ADDENDUM NO. 1

PROJECT NAME: Henzlik Hall Roof Replacement (Phase II)
UNL PROJECT NUMBER: C055P112
UNL INVITATION NUMBER: 2065-13-7215

CONSULTANT: Jackson / Jackson Associates
ADDRESS: 1905 N. 81st St. Omaha, NE 68114

DATE OF ISSUANCE: Wednesday, February 20, 2013
DATE OF BID OPENING: Tuesday, February 26, 2013

KEY PLAN

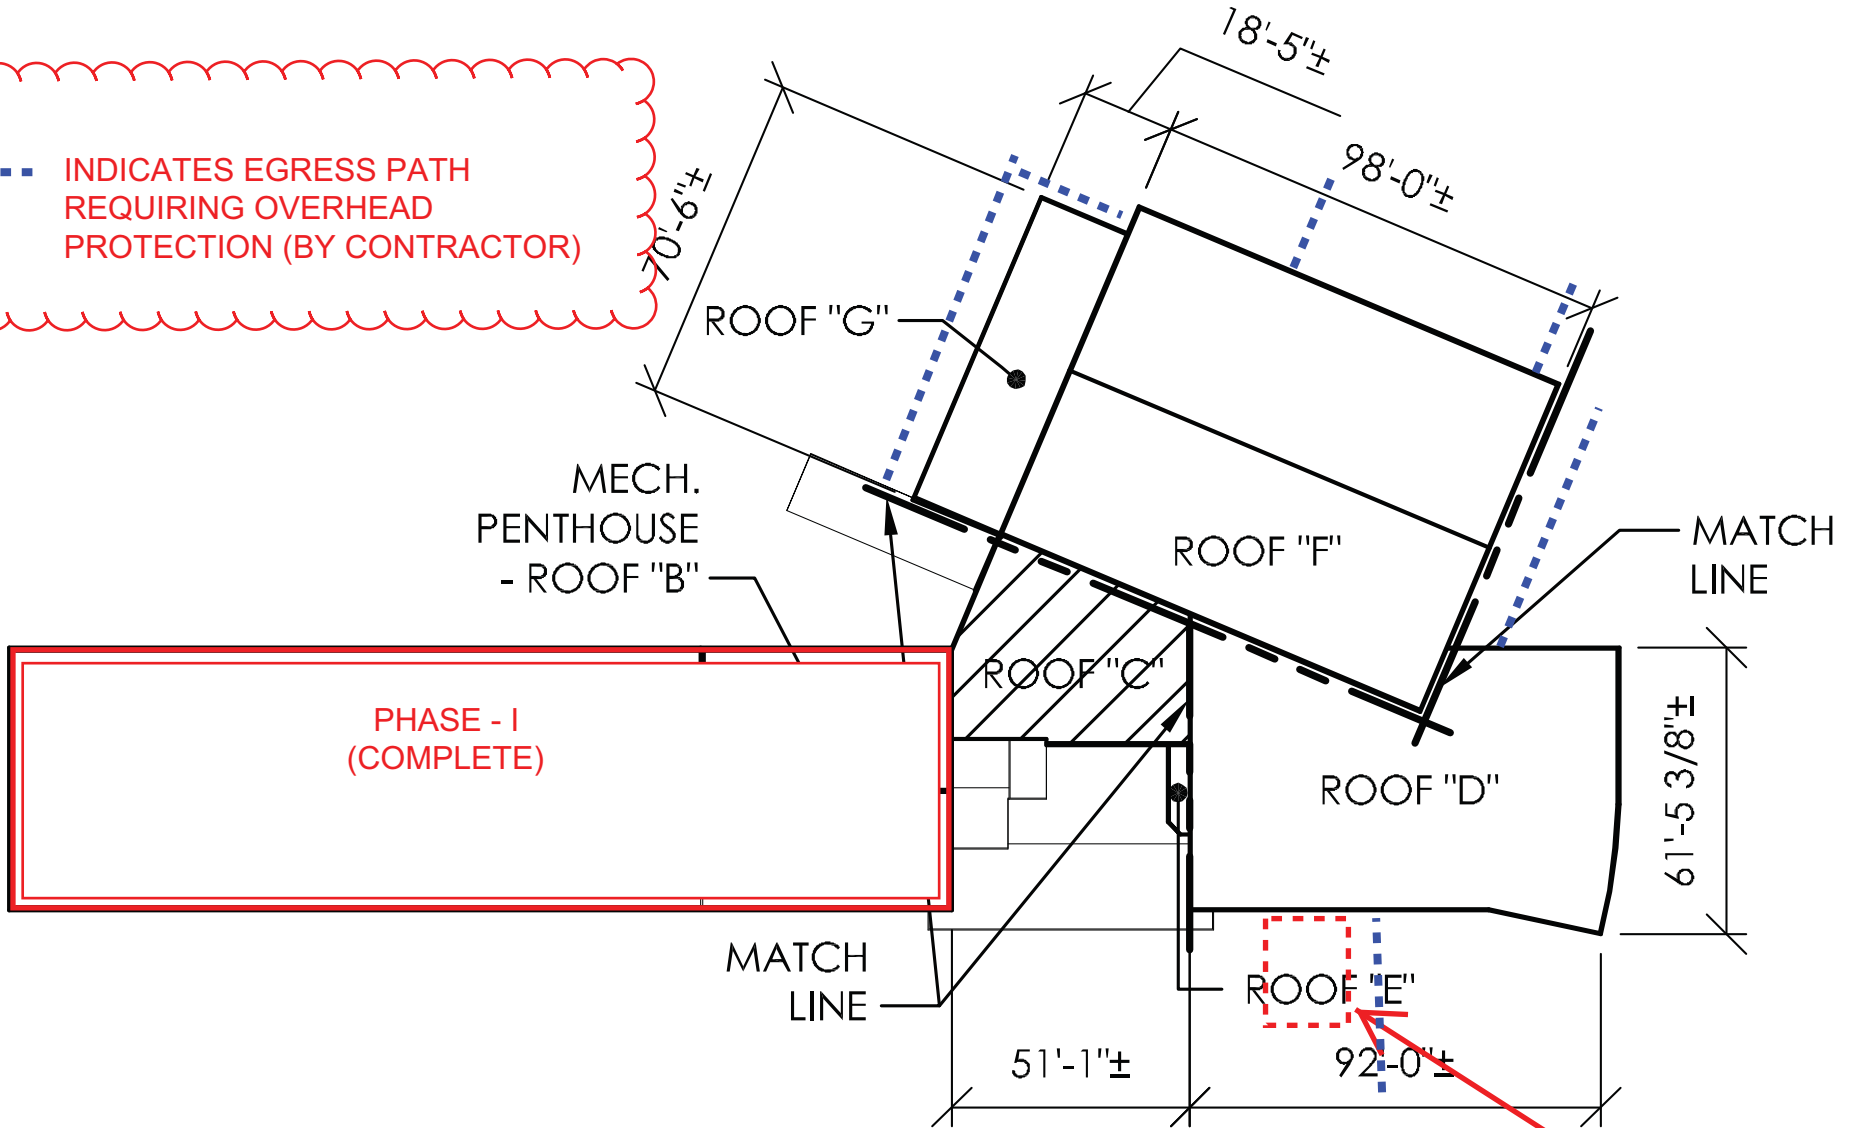
1. QUESTION: How far does the overhead protection need to run, past the edge of the building?
RESPONSE: Out to adjacent sidewalk or parking lot.
2. QUESTION: What is the height of the roof edge at "Roof D", from the ground level at the staging area?
RESPONSE: ±20-25 feet
3. QUESTION: What is the construction of the gym floor, and can a scissor lift be used to hang the dust protection in the gym area (Roof F)?
RESPONSE: The gym floor is a floating wood gymnasium floor on sleeper type wood blocks. A scissor lift is too heavy for the floor and therefore cannot be used.
4. QUESTION: Is overhead protection required at the courtyard sidewalk (located west of roof "G")?
RESPONSE: YES.

--- INDICATES EGRESS PATH
REQUIRING OVERHEAD
PROTECTION (BY CONTRACTOR)
